**Comments on the NPRM concerning: Federal Motor Vehicle Safety Standards; Roof Crush Resistance-
Docket No. NHTSA-2005-22143****Abstract:**

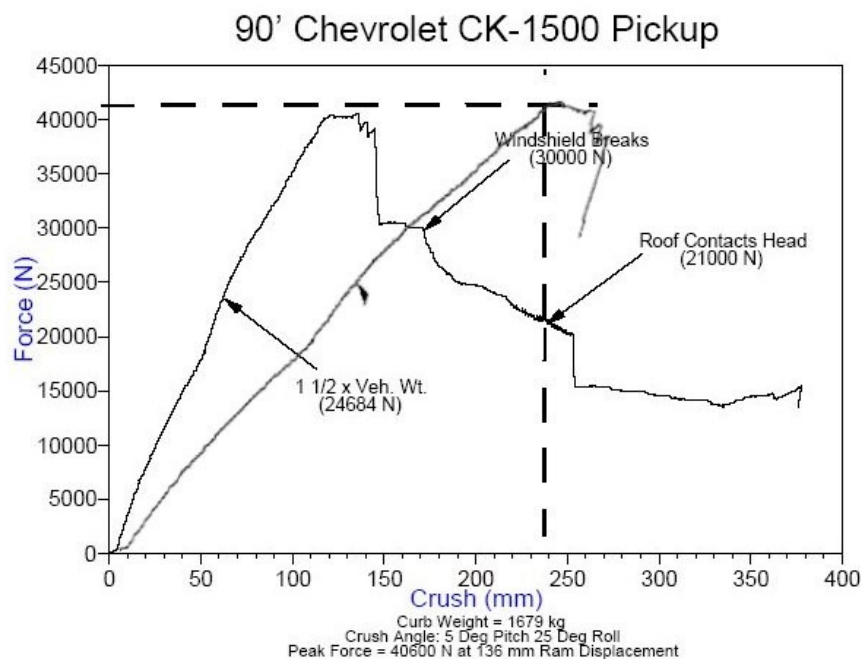
Notice that even with the new inside shoulder, seat mounted, pretensioner belt –what many would consider to be an optimal design- the dummy still moves up out of the seat and if not in contact with the roof is at least in close proximity to it. Worse, the head and neck are fairly well aligned thus increasing the chances of a serious spinal cord injury. Any roof encroachment here might still result in serious injury.

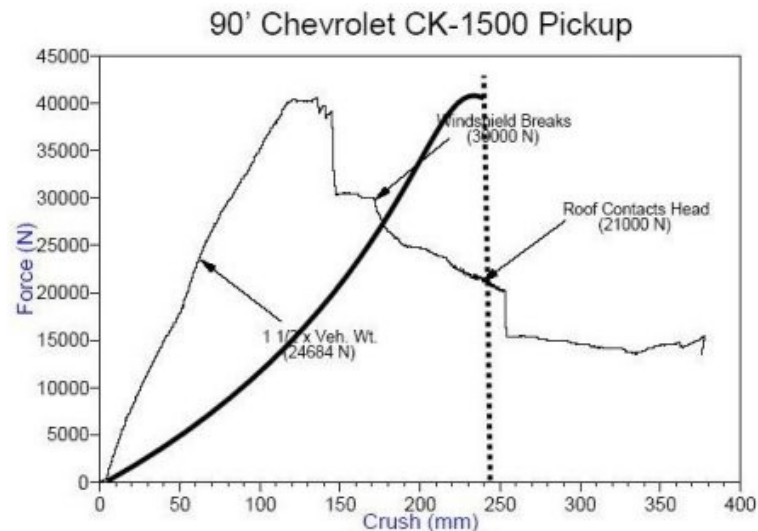
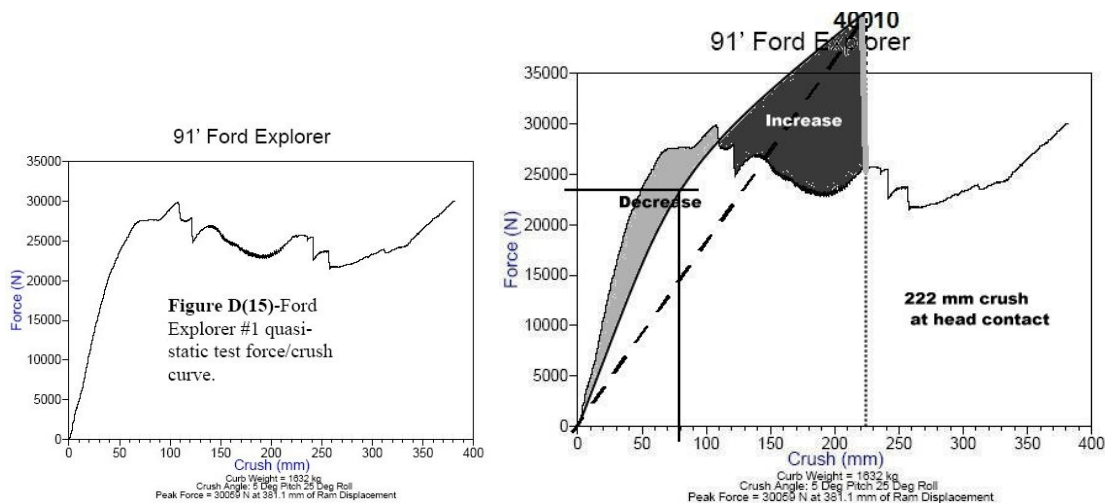
The proposed standard might well result in weaker roofs in some cases, if the manufacturers build down to the standard. In a case where roof stiffness increases linearly as the roof is crushed, the 10 inch deflection - already noted by NHTSA as required to reach the dummies head in some vehicles - in the new protocol will result in a roof strength of 1.25 g's at the 5" (actually 4.92") deflection level if 2.5 g's is required at 10" of deflection. This is less than the current standard requires. If roof stiffness increases at a rate greater than linear, as is generally the case now, the results could be even worse. The basic problem is revealed when we note that the average roof crush at the point of head contact noted in reference [4] was 194 mm or 7.64". Now: $2.5 / 1.5 = 1.66$, and $1.66 \times 5" = 8.33"$. In other words, the proposed increase in force is close to the increase in allowable crush distance on the average. Increasing the crush distance allowed in the test tends to negate the effects of the increase in peak force requirements, a fact that in the future could have repercussions on the entire installed fleet. Consider the following illustrations:

The force- deflection diagram was taken directly from reference [4.] The curve was copied, reoriented and stretched until it met the new peak force requirement at 2.5 x vehicle weight - 41,123 N. at the head contact distance noted in the original test. Note that the '90 model year vehicle almost met the new load requirement at the old distance: 125 mm, 5". But under the proposed criteria, GM could now stretch it out so that the load requirement is met at about 236 mm or 9.29". This means more crush at lighter loads and a net decrease in performance. GM might even do this, further decreasing the strength of the roof at light loads:

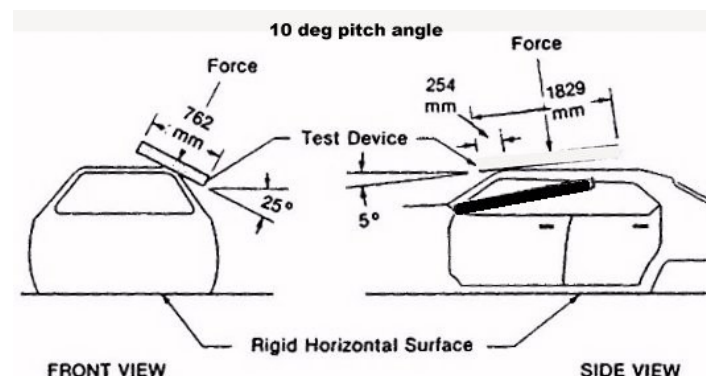
This could be done in a number of ways, including the use of a thinner or more recessed headliner, thinner seat cushions, adjustable height seats (using cheap manual adjusters) set to the lowest (uncomfortable, unusable) seat position or by changing the seatback angle. Do SUV manufacturers get to use the seatback rakes found in sports cars? If an upright 18-19 degree angle is mandated, will the dummy "fit comfortably" in a low roof vehicle or will manufacturers be able to increase the angle for a "typical comfortable" seating position? Who decides what a "comfortable" seat back angle is? If the middle setting is specified for the seatback angle, what is to prevent the manufacturer from adding a few notches in the down direction? Worse, with a fully reclining bucket seat in an SUV, a midpoint setting might allow two feet of crush. If the most upright setting is specified, why can't they take a few notches out? Does the agency anticipate having to regulate seat back angle adjustments or make reclining seats illegal? (Here's a plan to pass to pass anything and everything: Allow seatbacks to recline to more than horizontal, allow 120 -130 degree angles relative to vertical, if the seatback hits the rear seat, remove the rear seat, many are removable now anyway. The midpoint between 10 degrees and 130 degrees is 70 degrees, 20 degrees above pure horizontal, the head might be below beltline level !)
